Re: Turkey Point Units 3 and 4
Docket Nos. 50-250 and 50-251
Administrative License Amendment Request No. 217 Regarding
Operating License Conditions and Technical Specifications

Descriptions of the proposed TS and OL changes with supporting justifications and a no significant hazards determination and environmental consideration are provided in the Enclosure to this letter.

Figure 3.1-2
BORIC ACID TANK MINIMUM VOLUME (1)
Modes 1, 2, 3 and 4

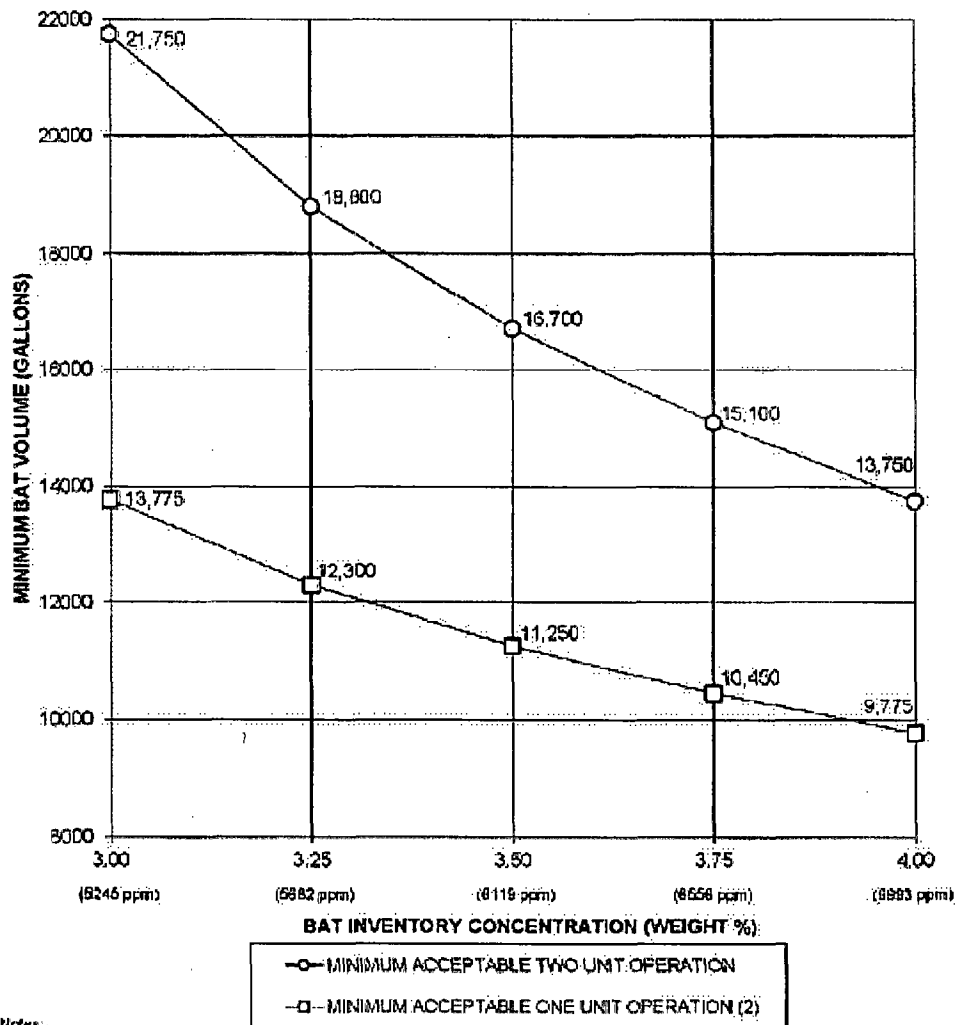
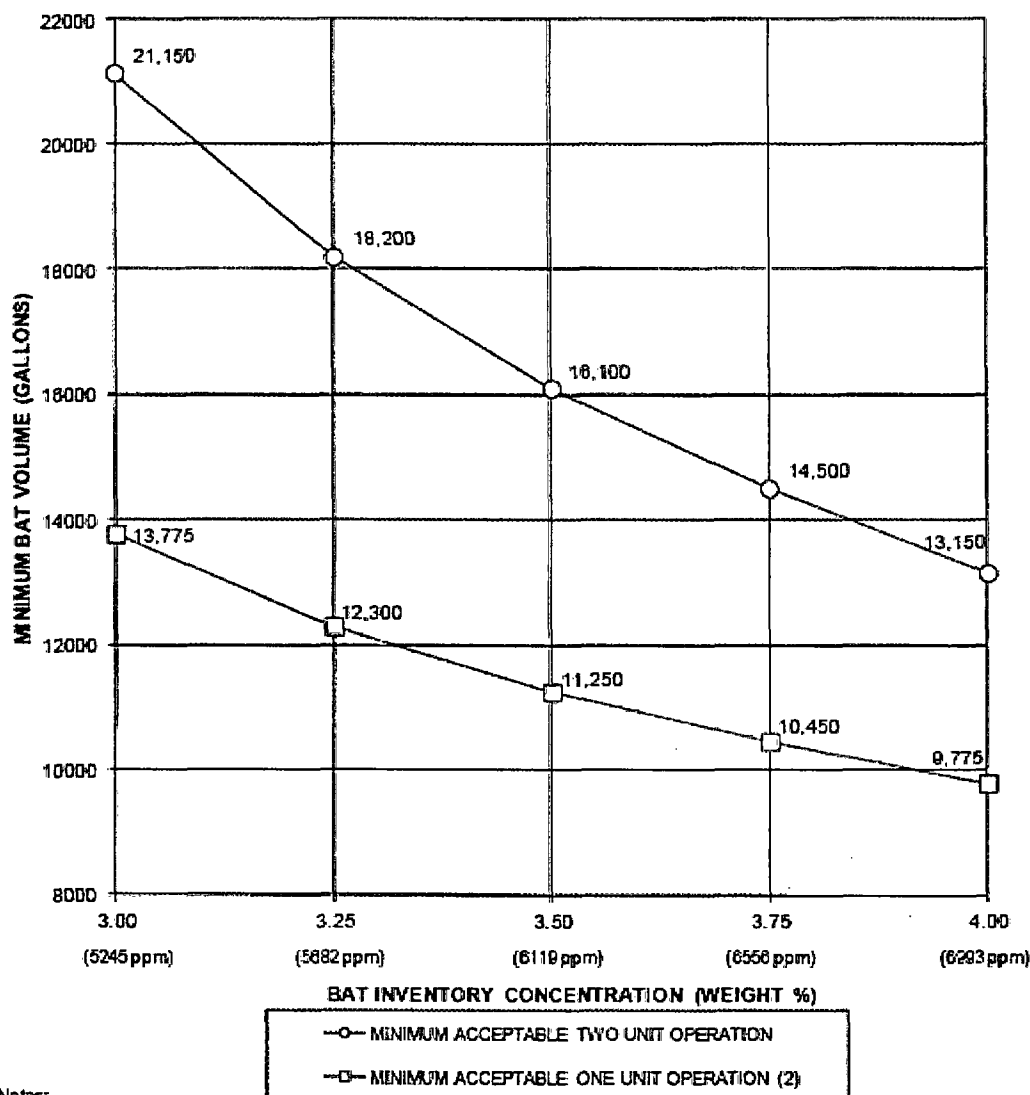
Basis for the Change: An instrument uncertainty of 600 gallons was applied to the Boric Acid Tank (BAT) minimum volume curve for one unit operation and then doubled to 1200 gallons for the BAT minimum curve for two unit operation via L-2011-560 dated January 10, 2012 [Reference 9]. However, the BAT is common equipment that serves both units so the instrument uncertainty for two unit operation should not have been counted twice.

FIGURE 3.1-2
BORIC ACID TANK MINIMUM VOLUME (1)
MODES 1, 2, 3 AND 4

FIGURE 3.1-2
BORIC ACID TANK MINIMUM VOLUME (1)
MODES 1, 2, 3 AND 4

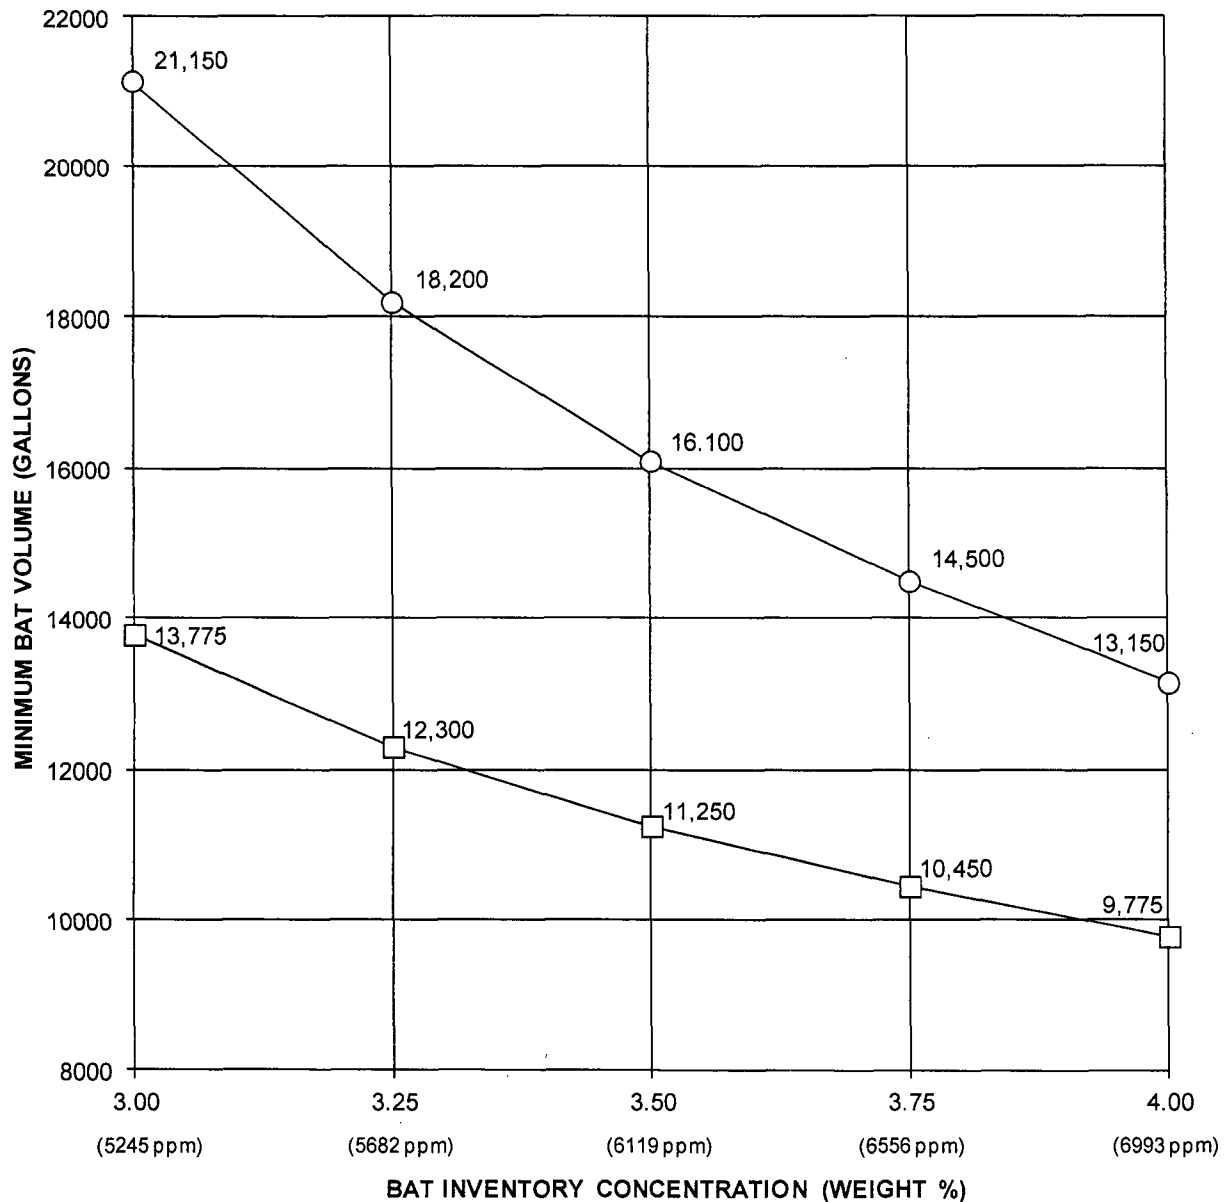
The proposed amendments will correct an inadvertent error identified in TS Figure 3.1-2 in which the boric acid minimum volume curve for two unit operation was overcompensated for level instrument uncertainty when the correction was applied twice for the same boric acid storage tanks, i.e., these tanks are common components shared by both units.
